Accessibility Survey

City of Downey Texas Street - Downey Avenue to Dolan Avenue

Date of Inspection
8/11/2017

Prepared By
Disability Access Consultants
(800) 743-7067

Change in Level West of Dolan Avenue @ 33.935834211881, -118.135251402855

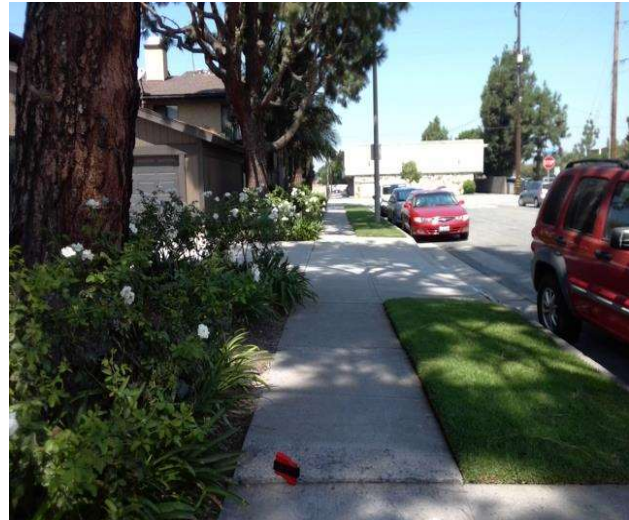
Sidewalks , Change in Level : Change in Level Non Beveled

There is a change in elevation greater than recommended value.

On-Site Finding 1.00 inches

Ensure that the change in elevation is within the recommended value.

Recommendation Up to 0.25 inches
